DEVIATION REQUEST AND DECISION FORM

Project Name : Grandwood Ranch
Schedule No.(s) : 6119000003
Legal Description : S2N2, EX PT TO HIGBY RD CONV BY REC# 205092691 W/MR SEC 19-11-66

DEV #5

PCD File No. SP-195

GRANDWOOD RANCH - FURROW ROAD
VERTICAL CURVE DEVIATION REQUEST EXHIBIT

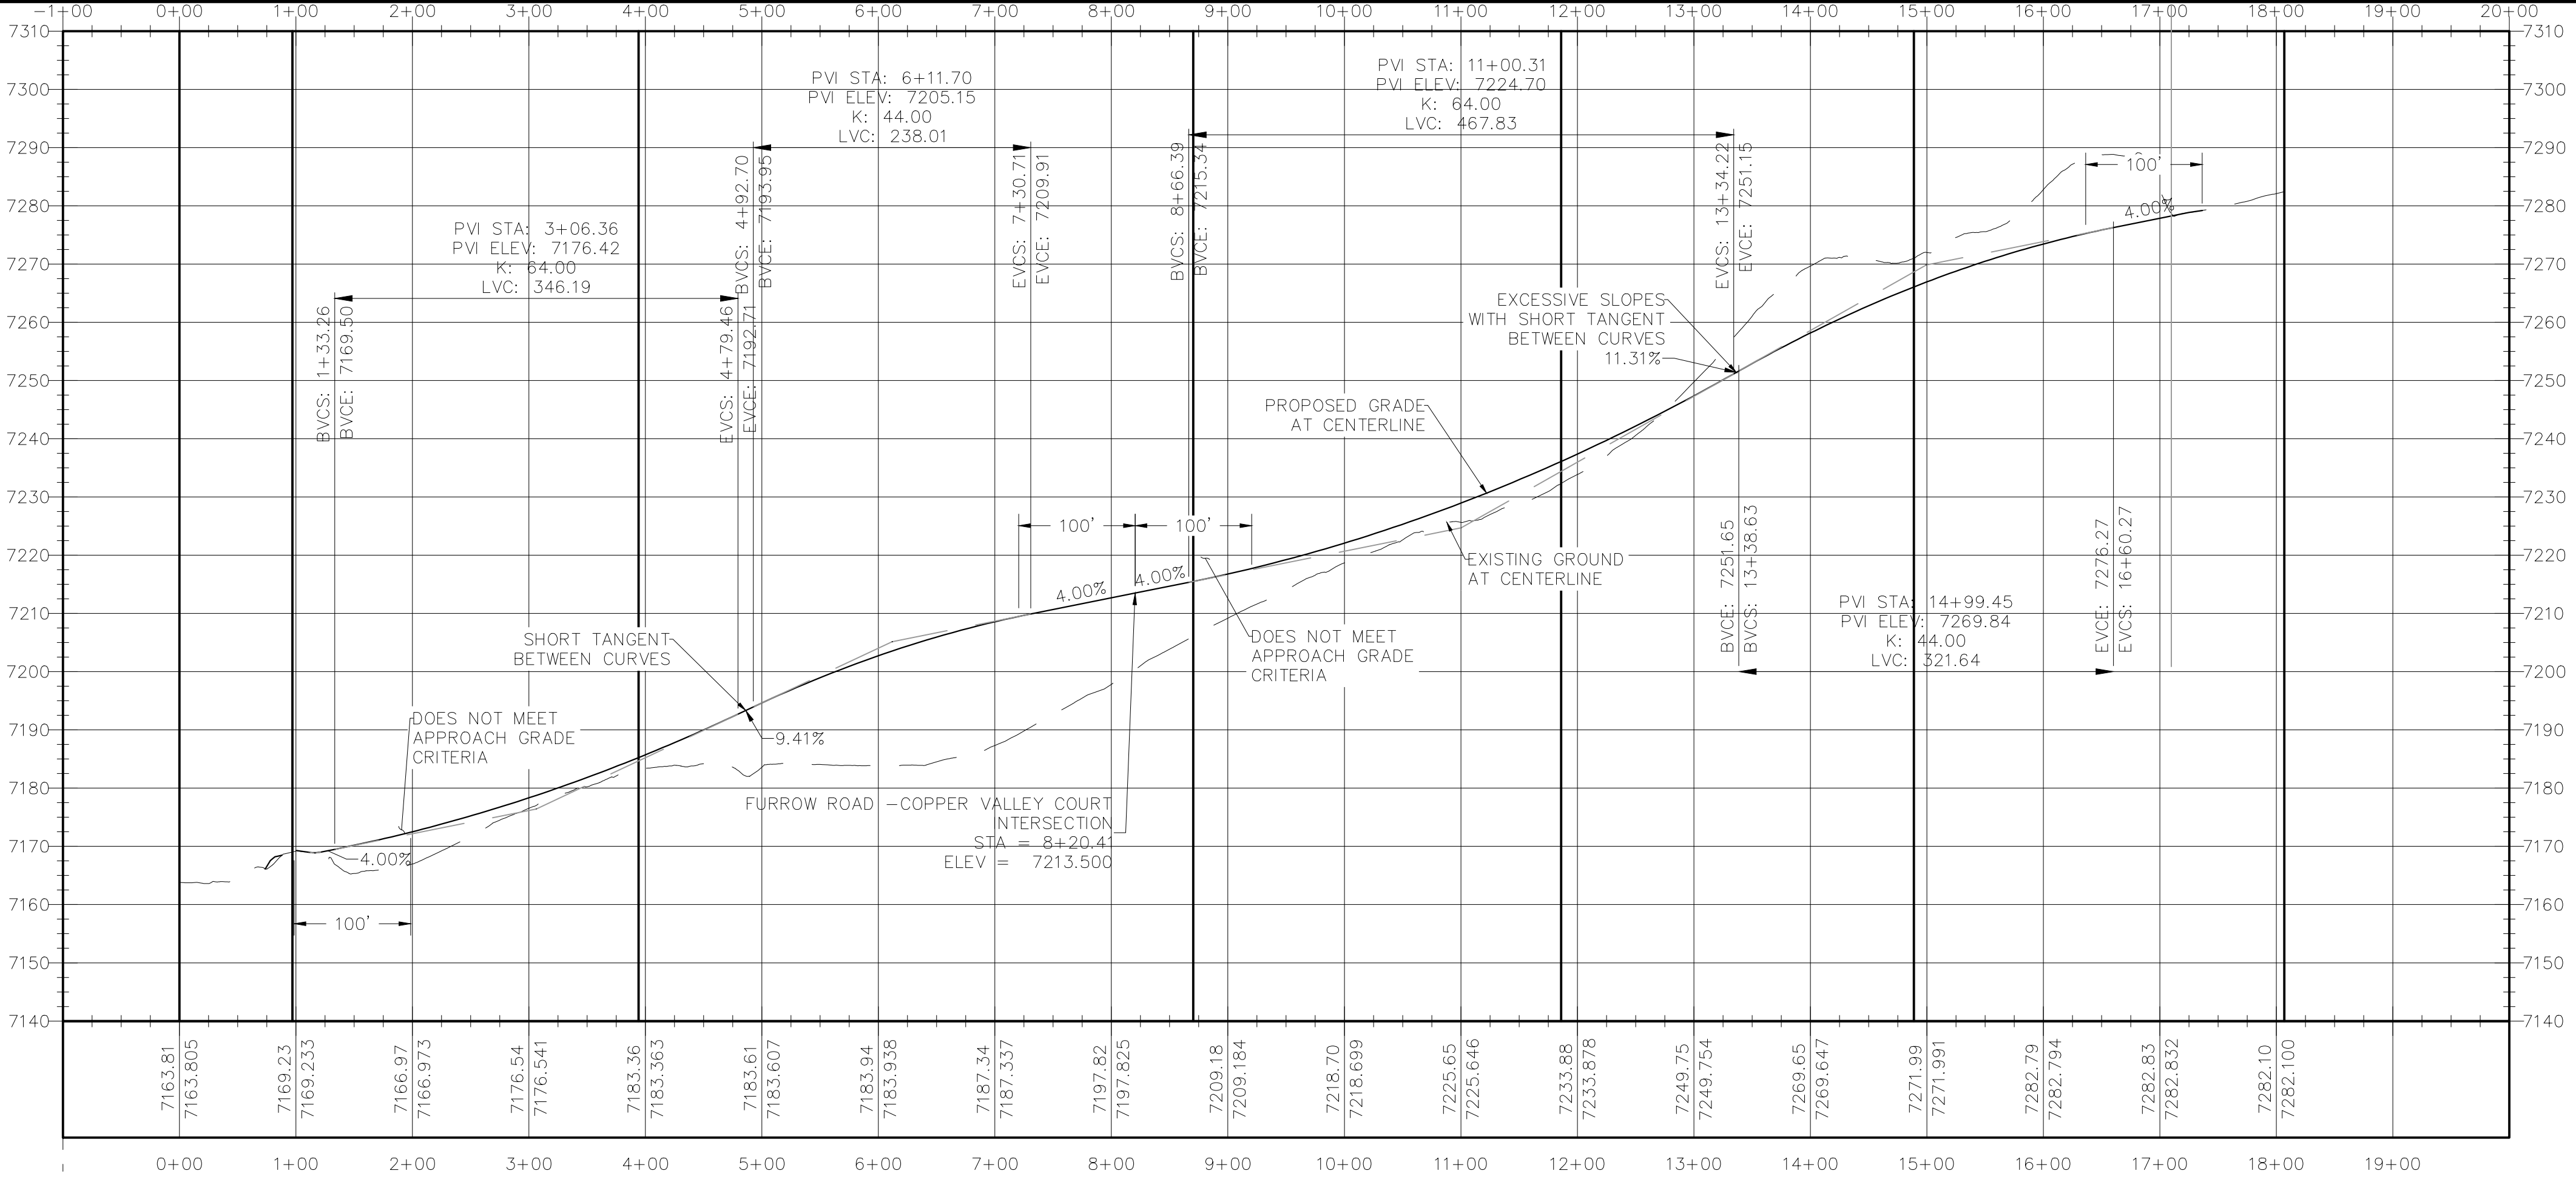
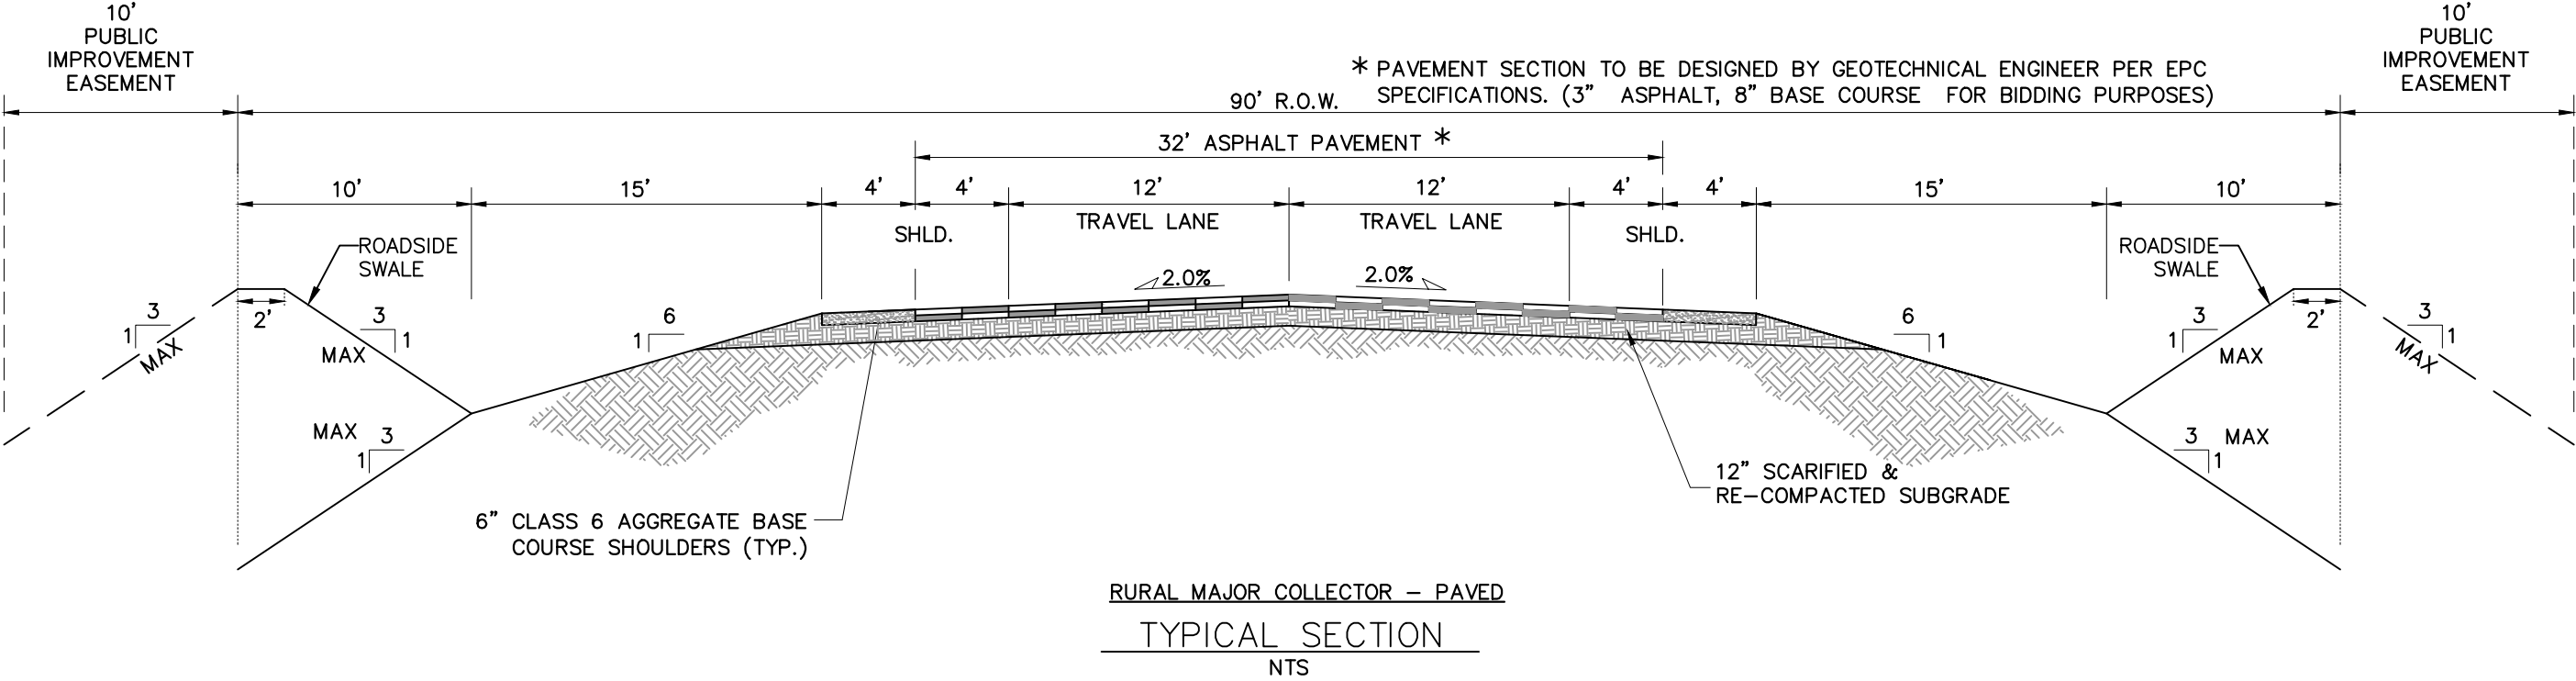
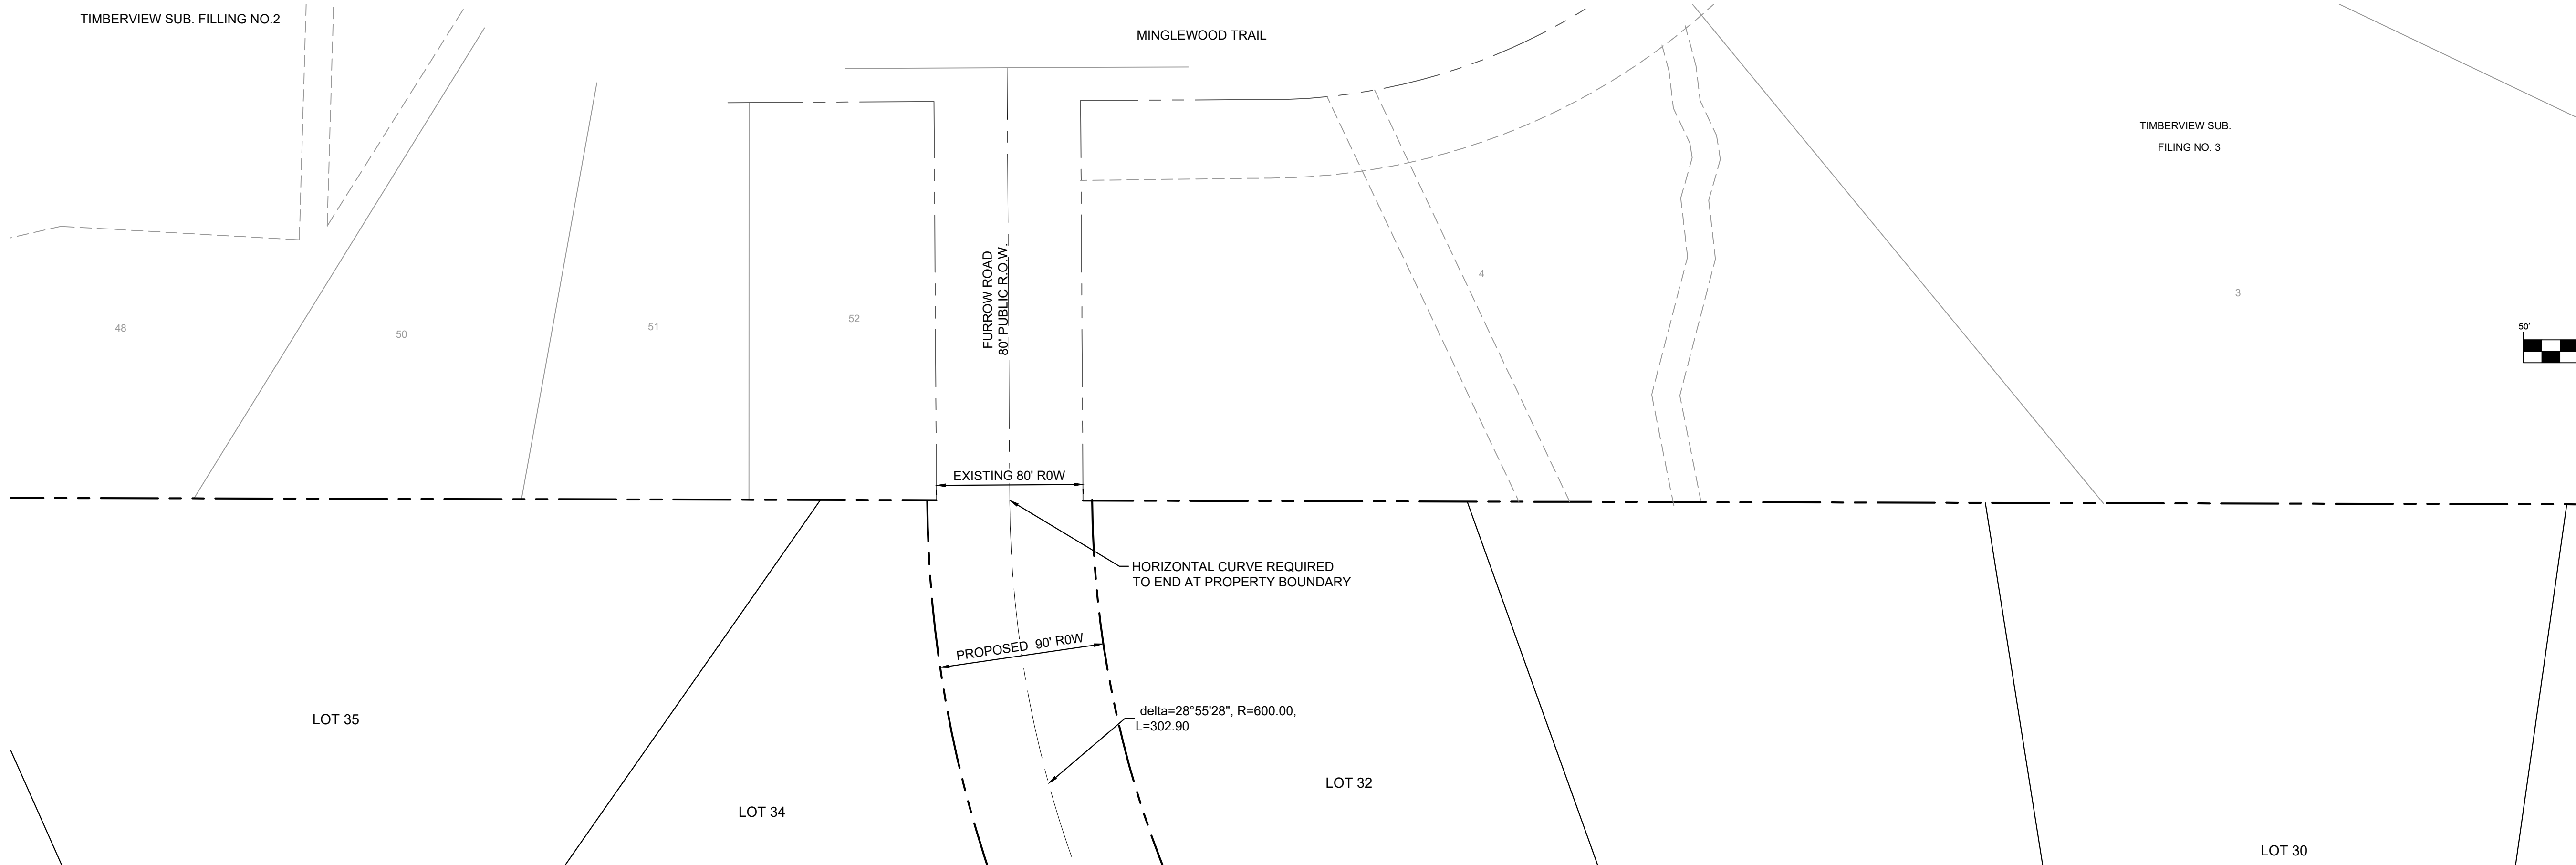
- Existing conditions along the Furrow Road alignment show approximately 113-feet of vertical fall resulting in an average 7% slope. With El Paso County criteria of 4% approach grade for 100-feet and, at a design speed of 40 mph, a K-value of 44 for crest curves and 64 for sag curves, there is not enough horizontal room to allow the vertical design of Furrow Road to meet Criteria completely. The attached exhibits provide a visual of the proposed vertical design with the approved deviation and with attempts at meeting Criteria. Using K-values with the proposed Furrow Road results in short and steep tangent sections between curves that exceed maximum limits and does not allow for proper approach grades at intersections for the required distance.

- A stop condition at the north and south end of the proposed Furrow Road will reduce travel speeds along Furrow Road and reduce impact of the reduced horizontal curve radius and the slightly reduced K-value on vertical curves. With reduced speed limits and stop conditions at both ends of Furrow Road, design will meet the intent of the Criteria. Reduced vertical curves along Furrow Road will allow the approach criteria to be met and ultimately allow the connection of Furrow Road and Higby Road as planned in the County's MTCP.

- Reduced K-values for vertical curves for Furrow Road will allow the approach grade criteria to be met which will provide safe travel while approaching intersections along Furrow Road.

GRANDWOOD RANCH - FURROW ROAD SECTION
DEVIATION REQUEST EXHIBIT

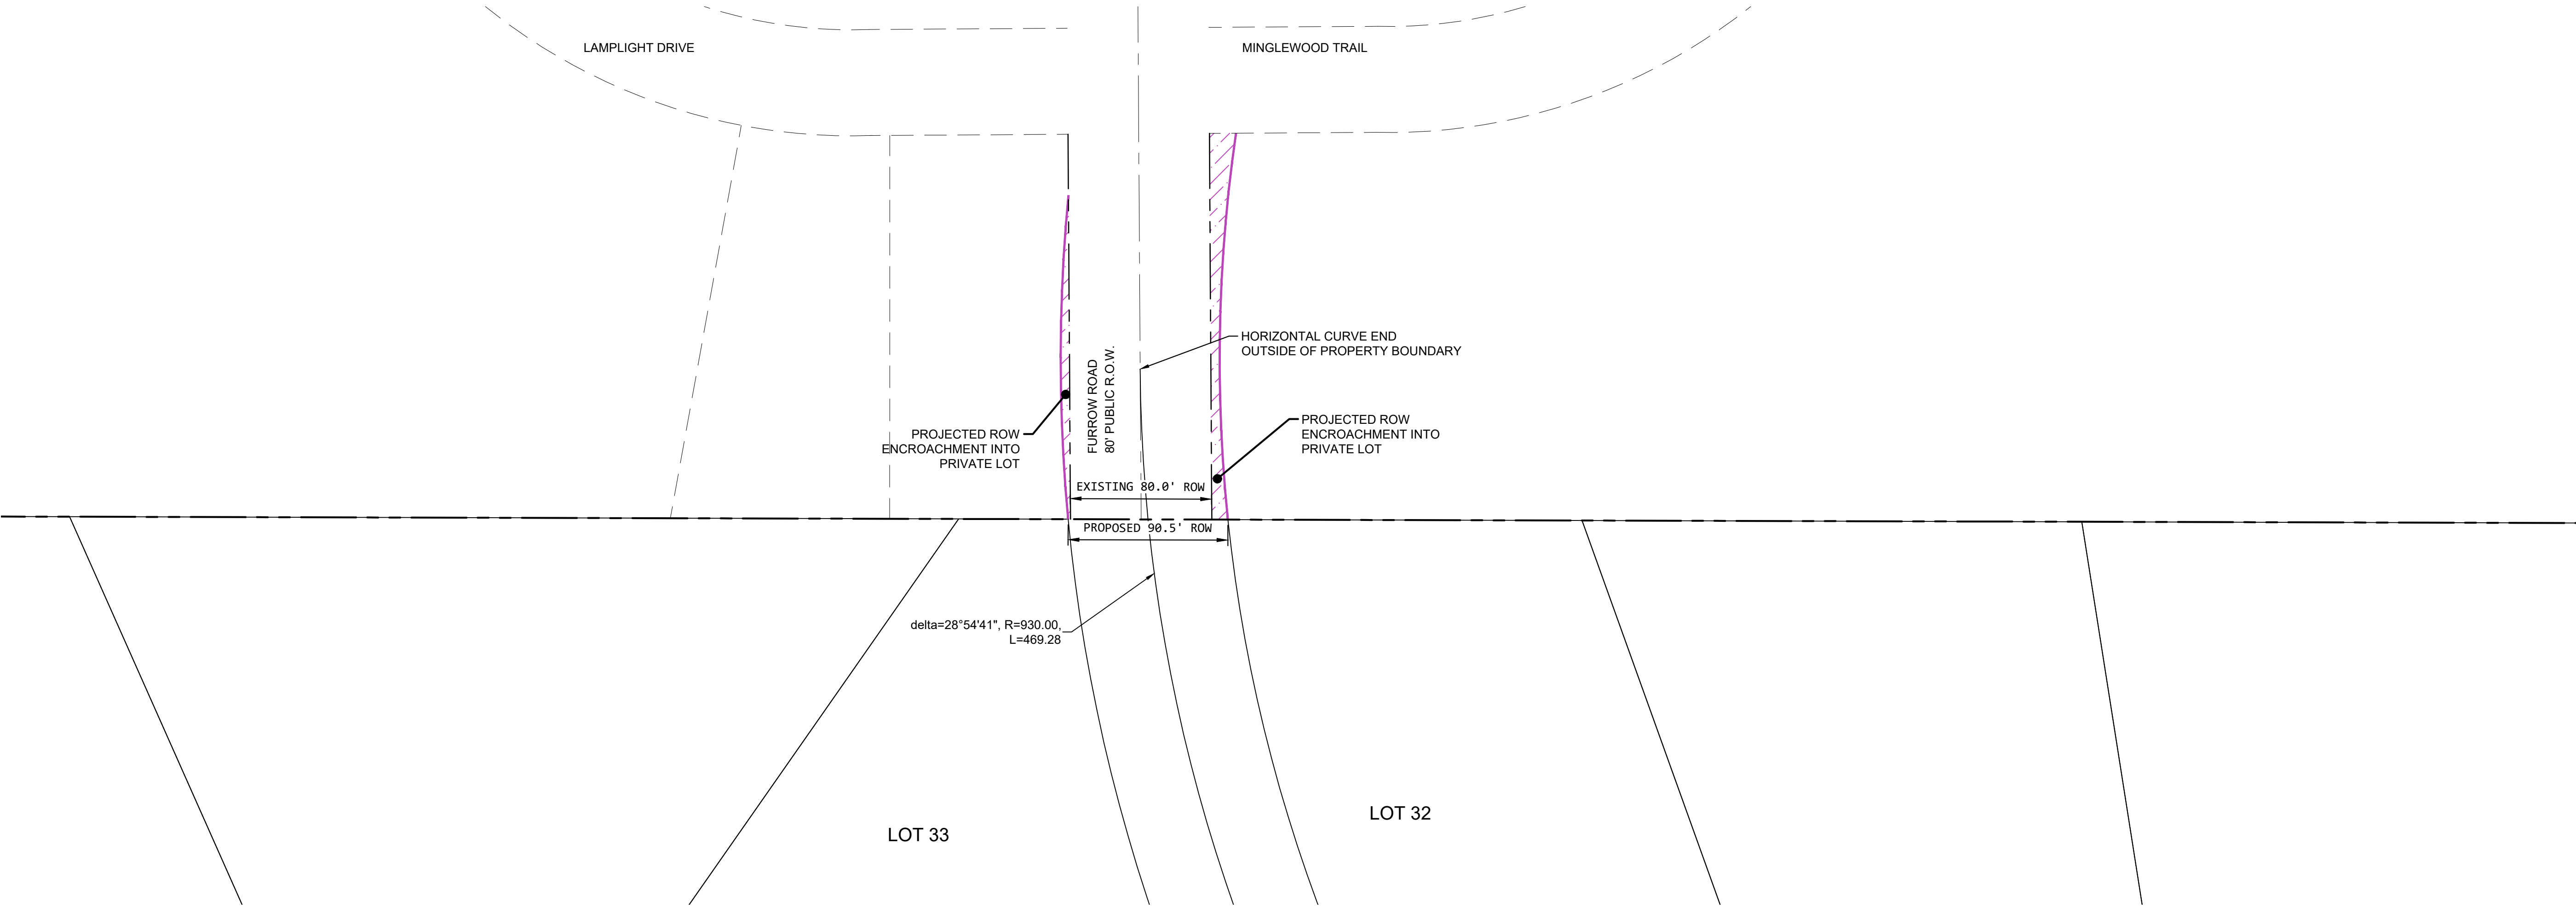
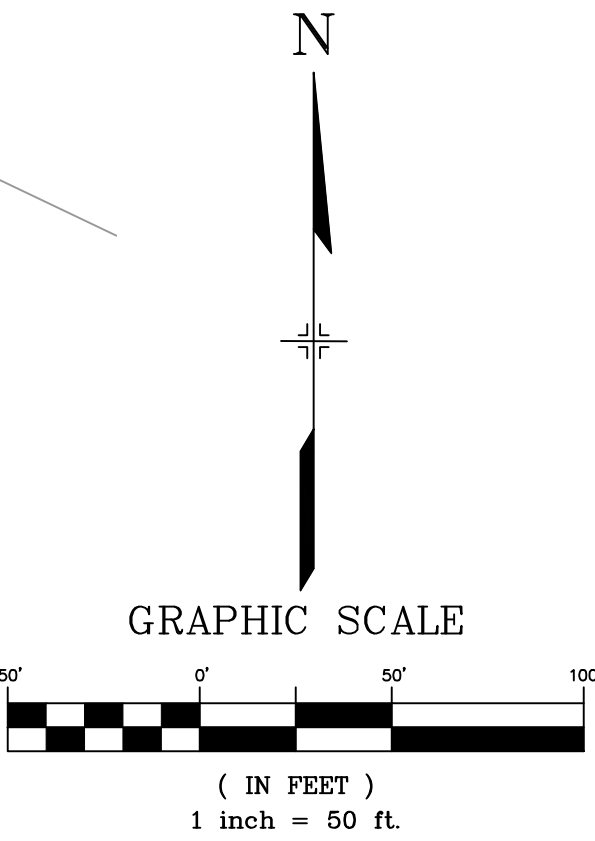
- Geometry previously shown with a 93-foot horizontal curve radius and 90-foot ROW resulted in public ROW encroaching into existing private lots within Timberview Subdivision. Please reference attached exhibit for further explanation on geometric constraints.

- The roadway will meet the County's geometric criteria for cross section and ROW width for a Rural Major Collector and design speed and horizontal curvature for a Rural Minor Collector. This roadway will be able to accommodate the projected traffic volumes and will add a significant benefit to the citizens and traveling public in this area – especially long term once the connection from Gleneagle to the south is established.
